APPLICATION NO.	FILING DATE	FIRST NAMED INVENTOR	ATTORNEY DOCKET NO.	CONFIRMATION NO
09/922,473	08/03/2001	Alex Urich	155696-0033	7208
1622 7	590 08/11/2004		EXAM	INER
IRELL & MANELLA LLP 840 NEWPORT CENTER DRIVE		•	THOMPSON, MICHAEL M	
SUITE 400	I CENTER DRIVE		ART UNIT	PAPER NUMBER
NEWPORT BI	EACH, CA 92660		3763

Application No.	Applicant(s)				
Office Action Summan	09/922,473	URICH, ALEX				
Office Action Summary	Examiner	Art Unit				
The MAII INC DATE of this accommiss the	Michael M. Thompson	3763				
The MAILING DATE of this communication ap Period for Reply	pears on the cover sheet with the c	orrespondence address				
A SHORTENED STATUTORY PERIOD FOR REPL THE MAILING DATE OF THIS COMMUNICATION. - Extensions of time may be available under the provisions of 37 CFR 1. after SIX (6) MONTHS from the mailing date of this communication. - If the period for reply specified above is less than thirty (30) days, a repleted in the provided for reply is specified above, the maximum statutory period Failure to reply within the set or extended period for reply will, by statuted the provided patent term adjustment. See 37 CFR 1.704(b).	136(a). In no event, however, may a reply be timely wit

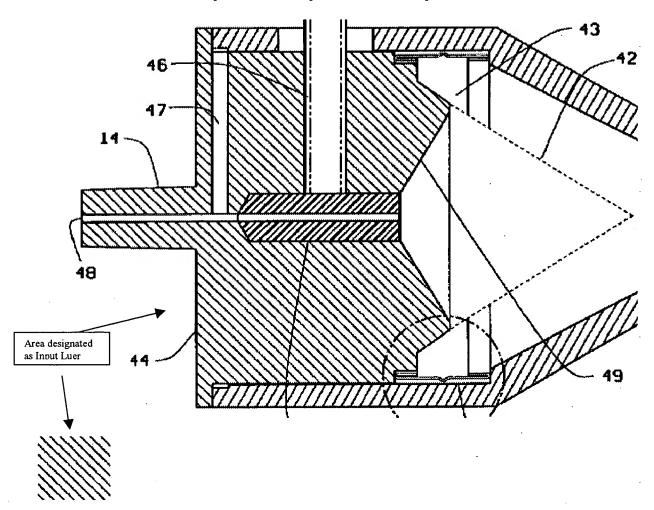
8. Applicant's arguments filed 03/26/2004 have been fully considered but they are not persuasive. In addressing Applicant's arguments with respect to Easley, Applicant should note the Abstract which recites all of the structural limitations recited by Applicant such as a flow restrictor and input luer. A correct depiction of Figure 3 shows a filter (42 or 43) that is not more than twice the size of the input luer and is pressed into the input luer. Shown below.

It is further the Examiner's position that a non linear relationship between fluid pressure and fluid flow rate is present in the Easley device. The mere fact that a flow restrictor and/or filter is within the pathway of the flow path provides a non linear relationship between the pressure and flow rate which is further affected by the control by the user. If Applicant disagrees then Applicant is directed to recite those structural features that provide the non linear relationship that are not recited in the independent claim. It is the Examiners position that the structural limitations have been met. In addressing obvious design choice relating to the flow restrictor, it is the Examiner's position that Claim 17 provides support for modifying the diameter of the restrictor. Lastly, the requirement to further address the means language relating to the material or acts is still outstanding and hasn't been completely addressed.
